Service Letter No. 404

**SUBJECT:** Inspection of Altimatic and Altimatic II Pitch Servo Assembly Chain Adjustment Screw

**MODELS AFFECTED:** PA-23 Apaches, Serials 23-1502 to 23-2046 inclusive  
PA-23-250 Aztecs, Serials 27-1 to 27-504 inclusive  
PA-23-235 Apaches, Serials 27-505 to 27-572 inclusive  
PA-23-250 (6 place) Aztecs, Serials 27-2000 to 27-2388 inclusive  
PA-24 and PA-24 "250" Comanches, Serials 24-2003, 24-2203, 24-2299 to 24-3557 inclusive

# SERVICE LETTER NO 404

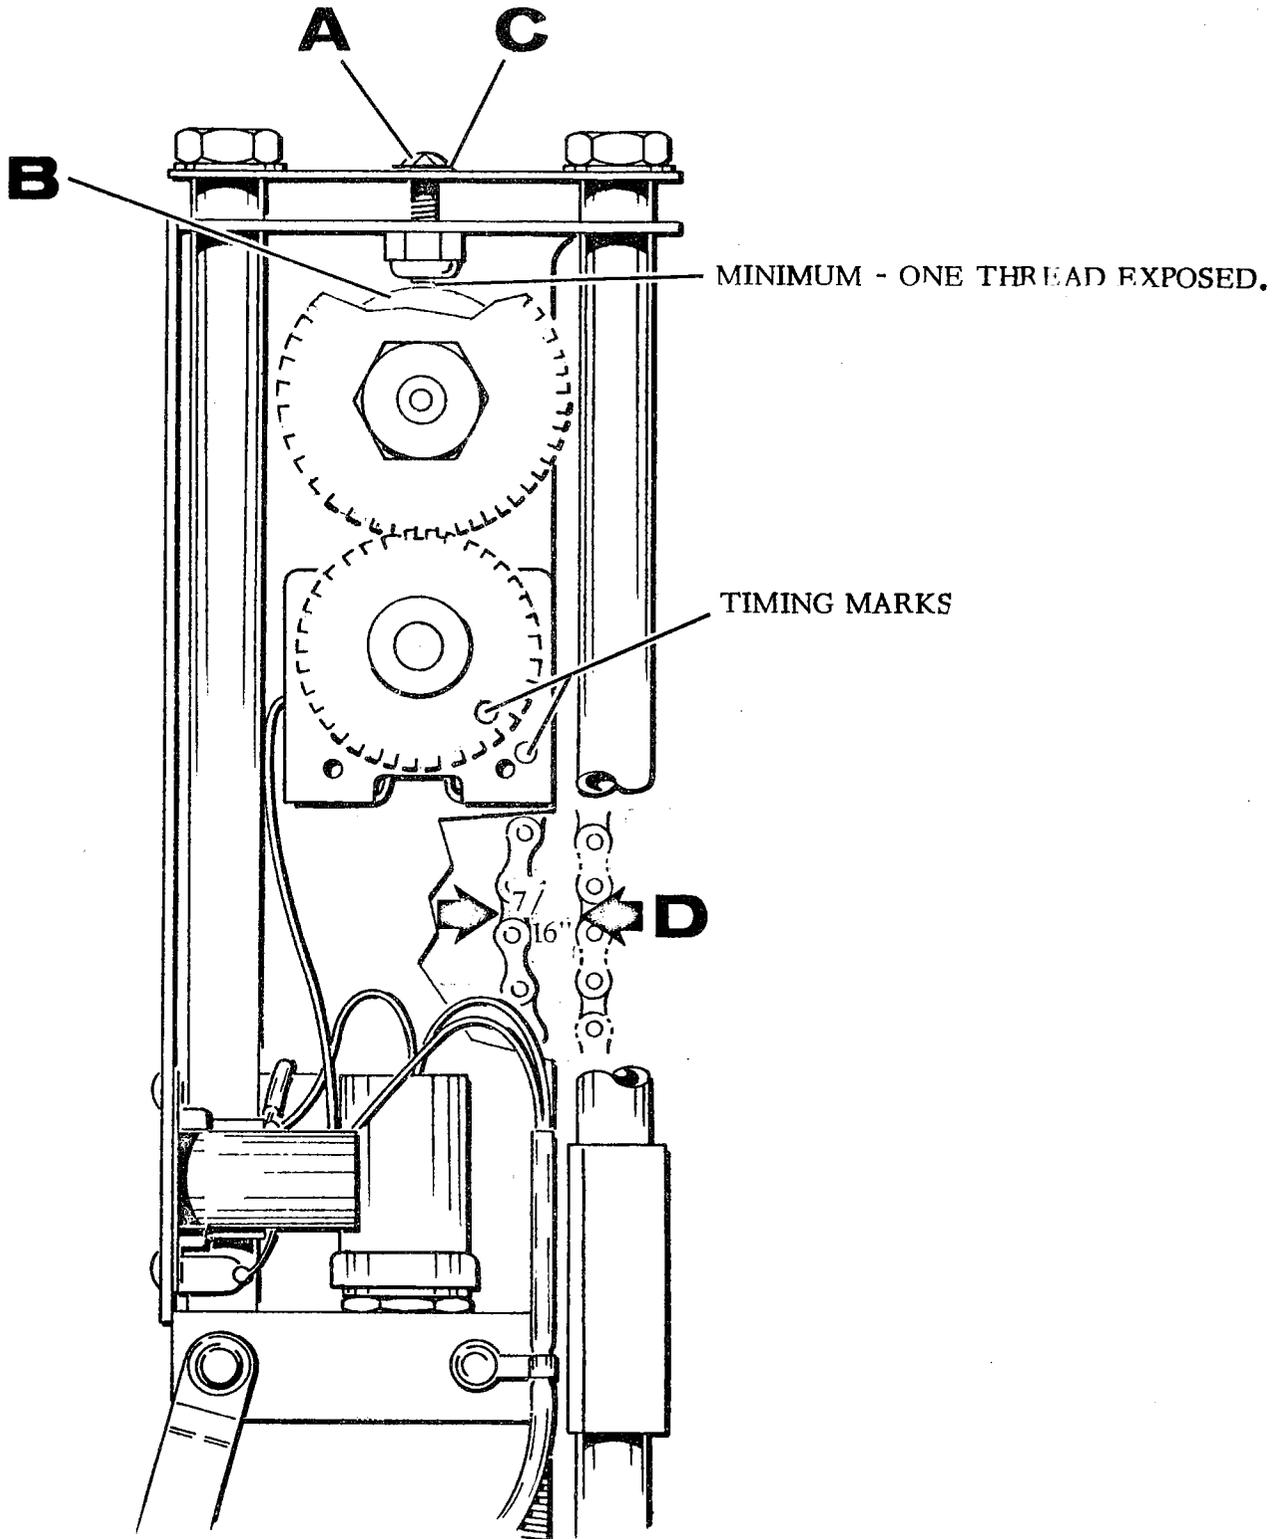
We wish to advise that it is necessary to inspect the chain adjustment screw in the pitch servo assembly in all aircraft equipped with Piper Altimatic or Altimatic II AutoPilots within the serial numbers listed above, and all pitch servo assemblies now in distributor or dealer stock. An inspection is requested to determine if the chain adjustment screw (Mitchell part number 3S60 and/or 3S103) is adequately engaged in the locking insert of the mating nut.

In order to provide a positive lock of the screw, at least one or more threads must protrude through the nut. If this cannot be accomplished without maladjustment of the pitch servo chain tension, (See pitch servo chain adjustment procedure on the following page.) it will be necessary to remove the screw and replace it with a "long-lok" type screw (Mitchell part number 3S275). Standard AN 1/32" thickness washers may be used as required under the head of the screw to prevent driving the screw end against the adjacent sprocket mounting.

1. Completely disengage the servo.
2. Measuring on the opposite side of the slide bushing or break-away link in the center of the servo, the chain should have approximately 7/16" slack.
3. By turning the adjusting screw clockwise, the chain tension is increased and by turning counter-clockwise, the chain tension is decreased.

See sketch attached to this letter for screw location and chain adjustment details.

IF LONG-LOK SCREW (A) CONTACTS SPROCKET MOUNTING (B), REMOVE SCREW AND INSTALL PACK WASHERS (C), UNDER HEAD OF SCREW AS REQUIRED TO MAINTAIN CHAIN TENSION OF 7/16" SLACK (D).
